Construction Change Directive

PROJECT: *(name and address)*
Highland Township Fire Station 2
PIA #18-122B

CCD INFORMATION:
Directive Number: 001
Date: July 13, 2021

“EXHIBIT A” – CCD NO. 1

M5-01 MECHANICAL DETAILS

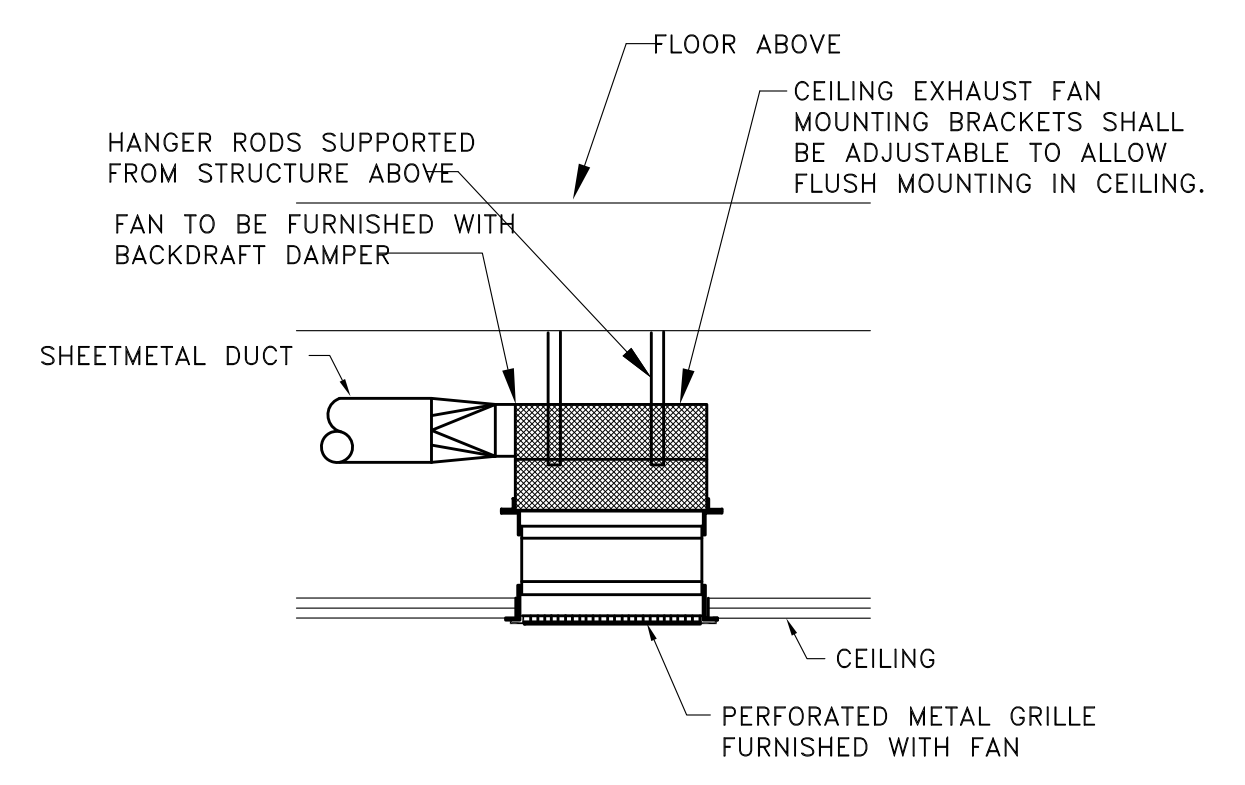
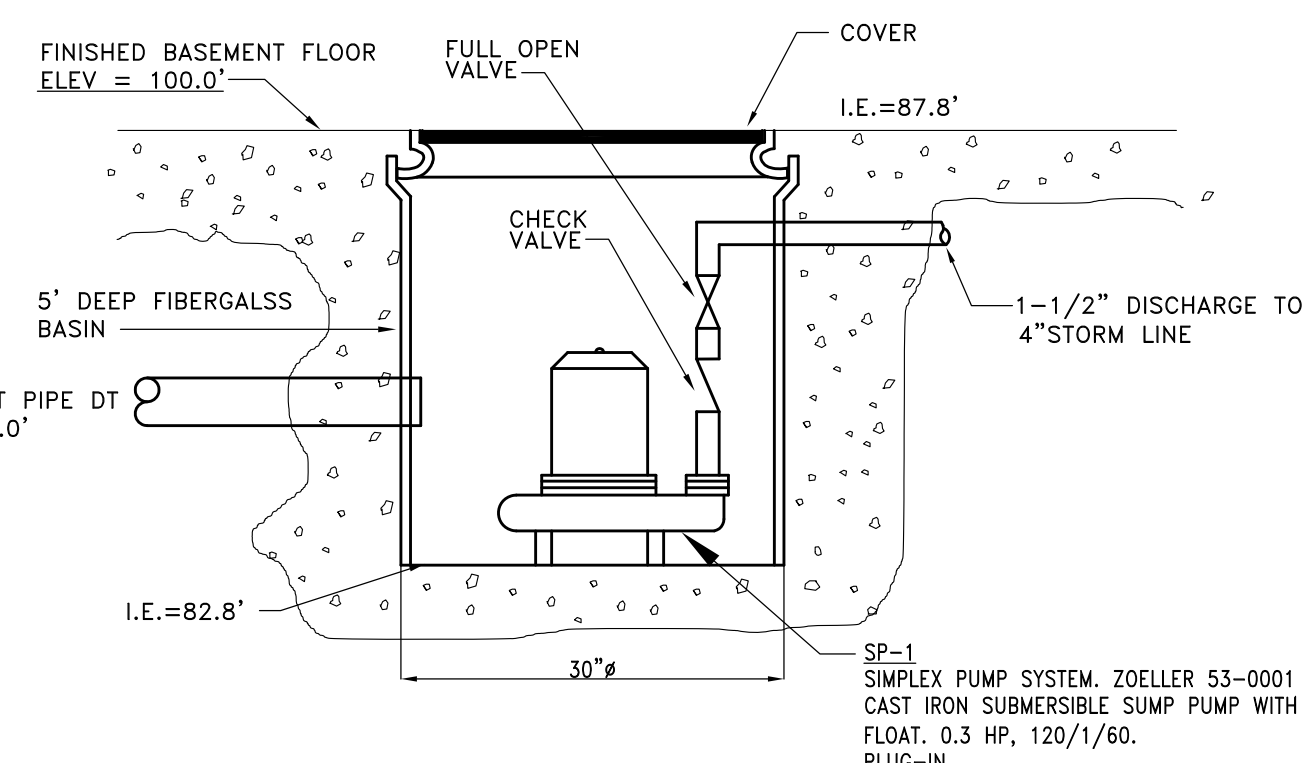
- A. Revise sprinkler riser and water meter diagram.
- B. Revise Heap pump floor diagram.

E3-00 FLOOR PLANS - POWER

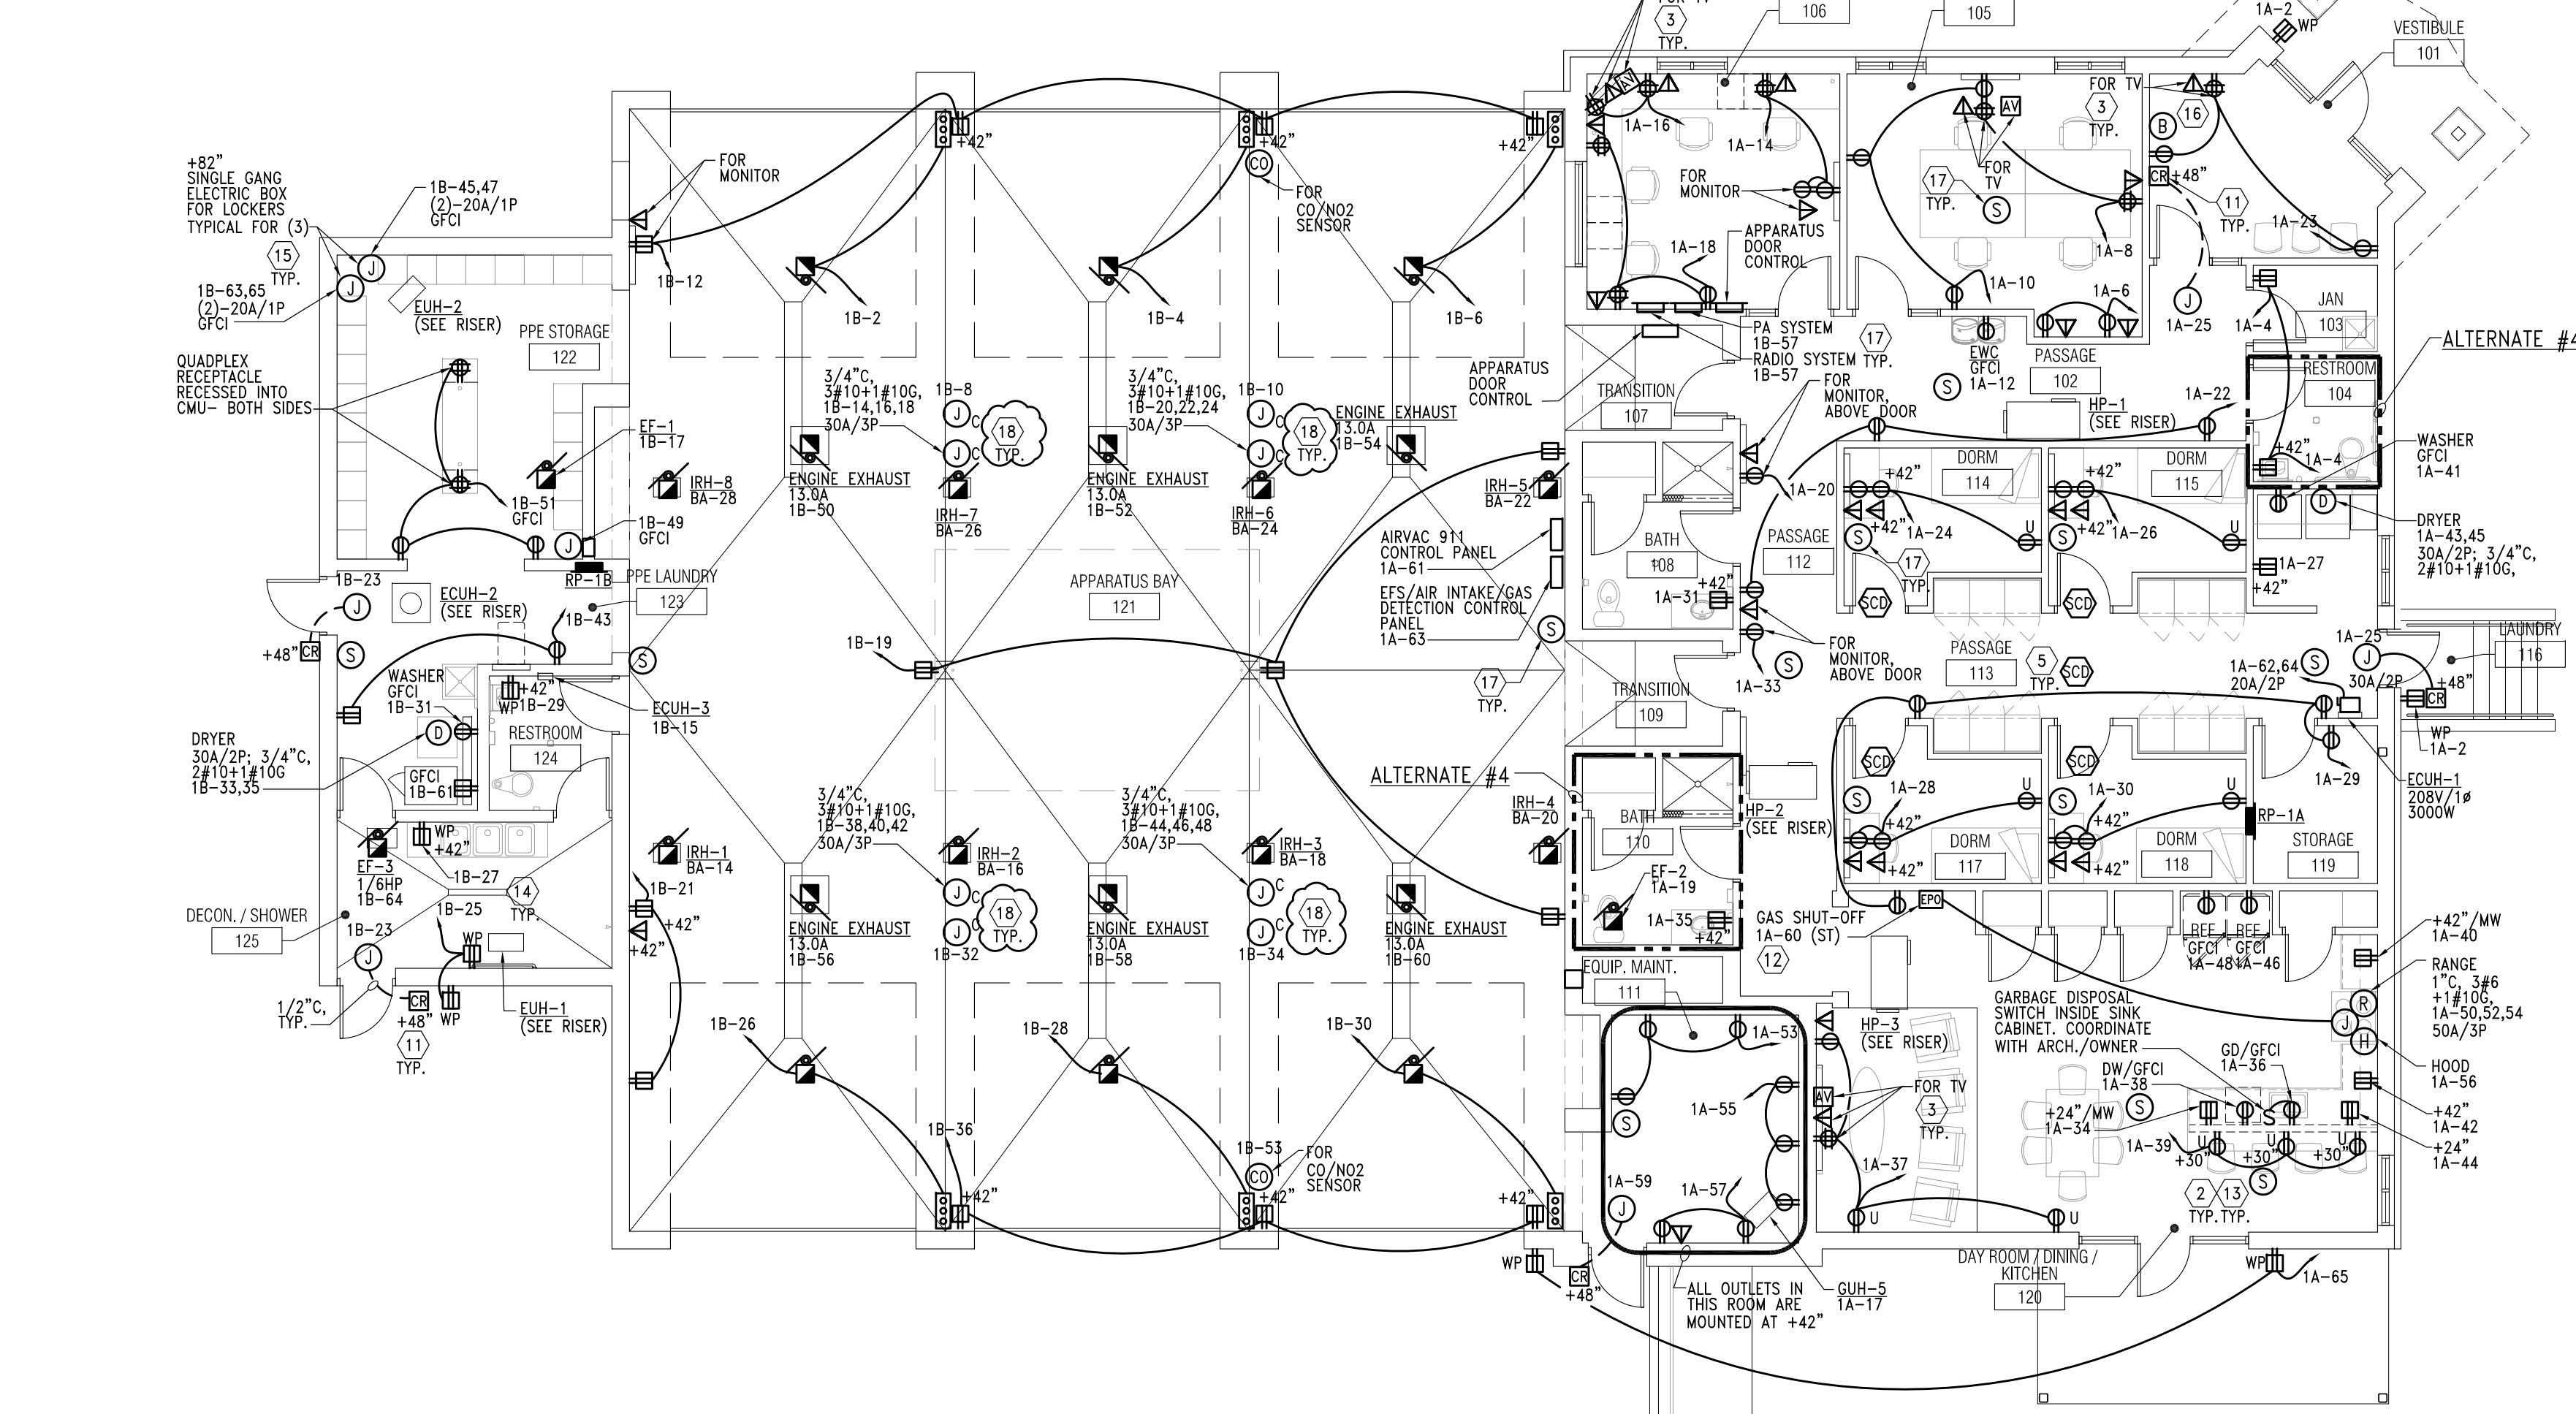
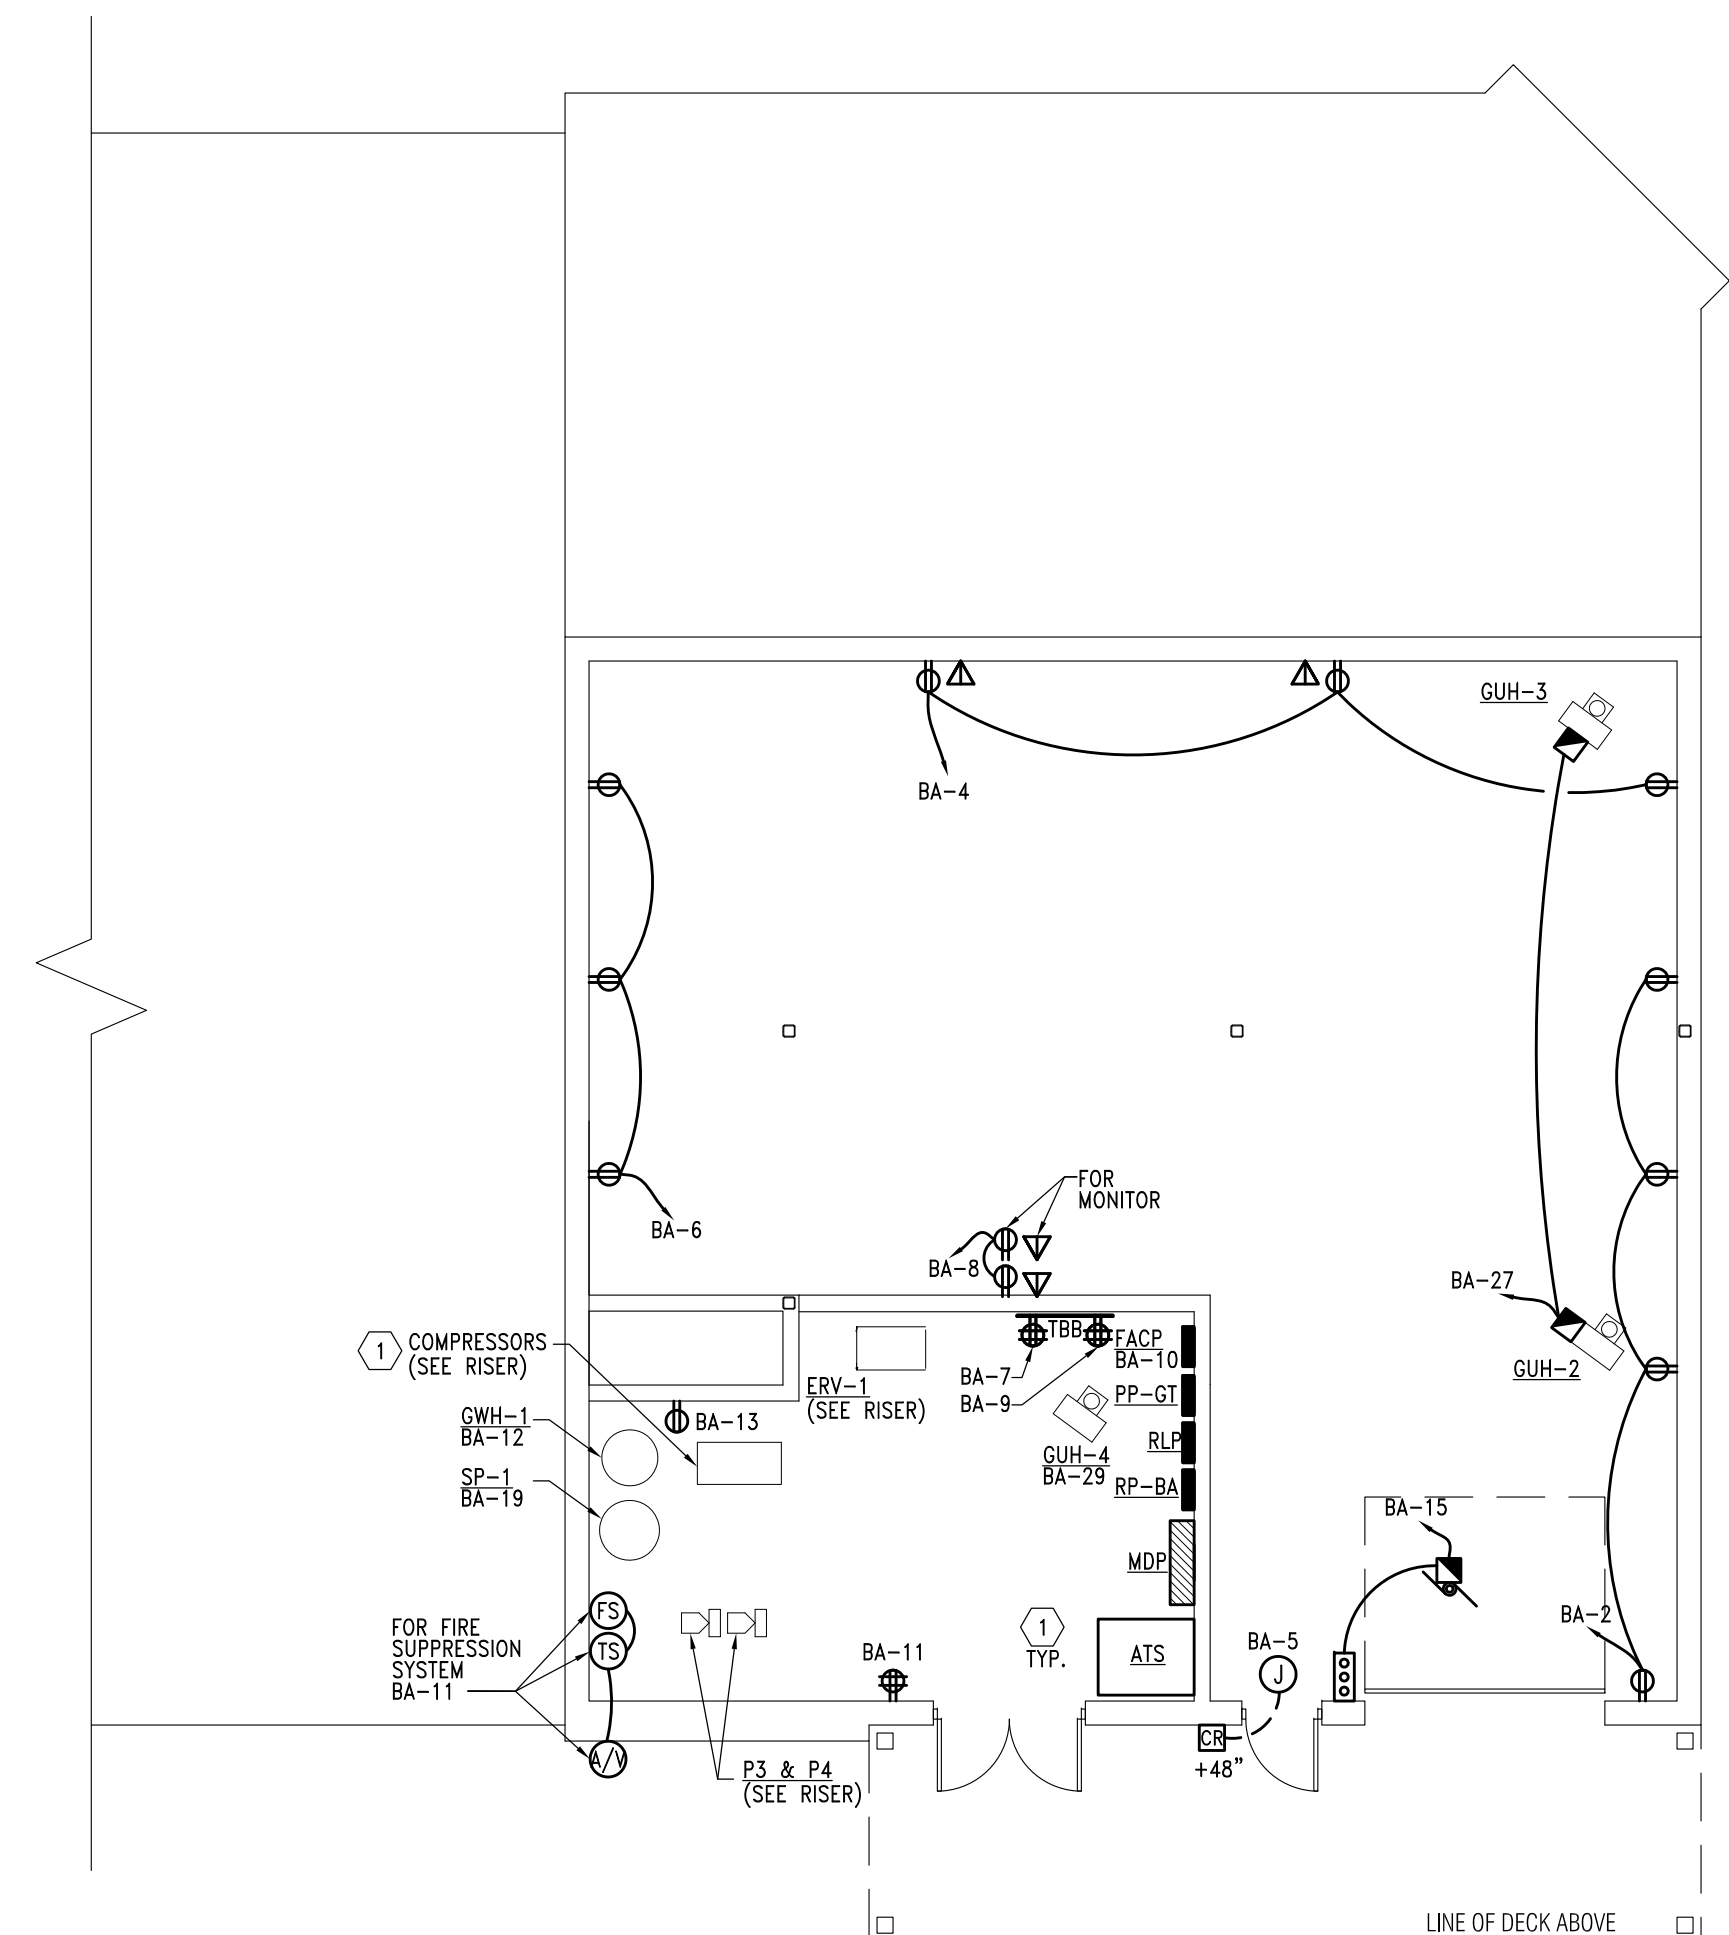
- A. Added Key Note 18 as indicated.
